**Specification for Heater Unit with Blower for
Diesel Electric Tower Cars**

Integral Coach Factory, Chennai - 38

CORRECTION SLIP NO.01 TO SPECIFICATION NO. ICF/ELEC/OHE/008 REV.00

ANNEXURE I modified and it shall read as follows.

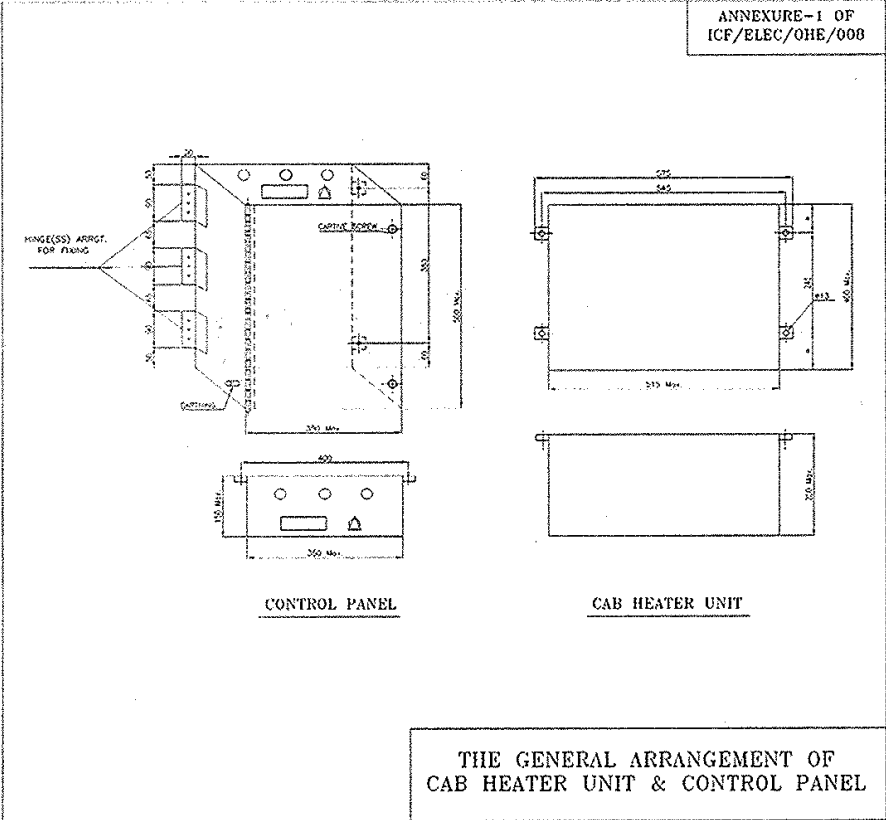
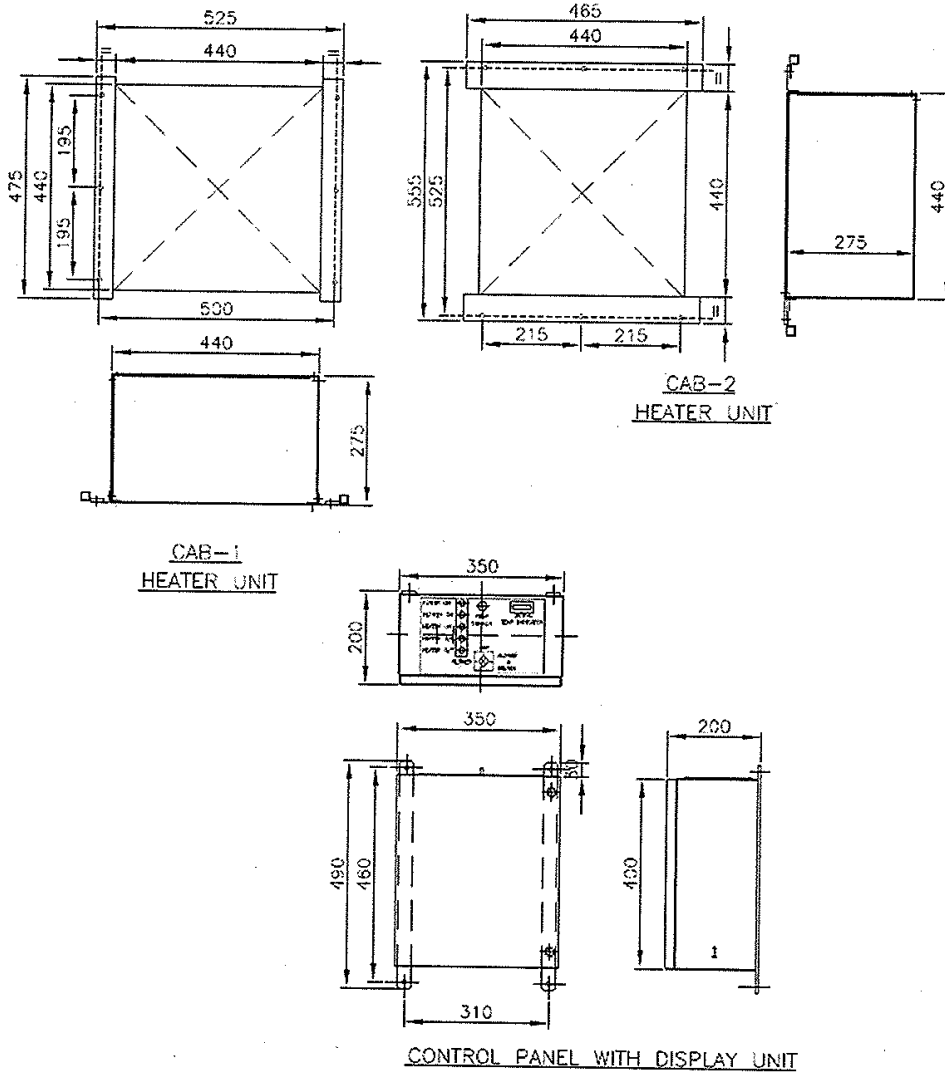
5) **Clause 5.8 modified and it shall be read as follows**

Due to space limitation in Driver's Cab I & Cab – II, different sizes of heater units are required as shown in Annexure-I. Height, width, depth are shown in maximum dimensions, however, reduced sizes of heater units are preferable duly retaining the mounting dimension as per the drawing to ensure the interchangeability. However, exact dimension can be decided jointly between ICF and supplier during detailed design stage.

ANNEXURE II added.

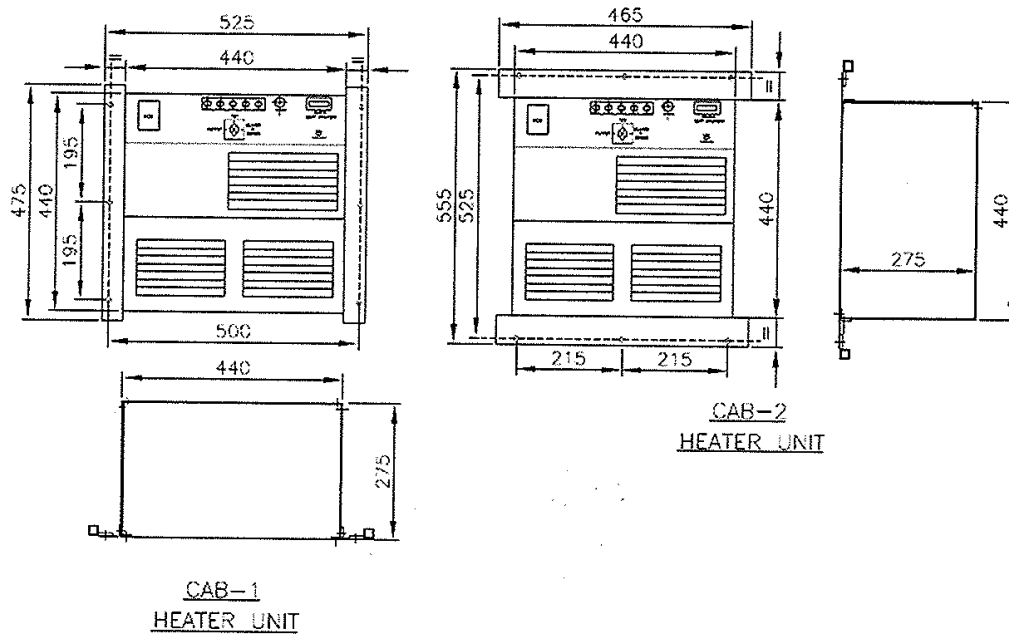
6) **Clause 5.9 added**

In case of adoption of integrated and compact single unit consists of Heater assembly, control panel and display unit shall have overall dimension as per Annexure-II.
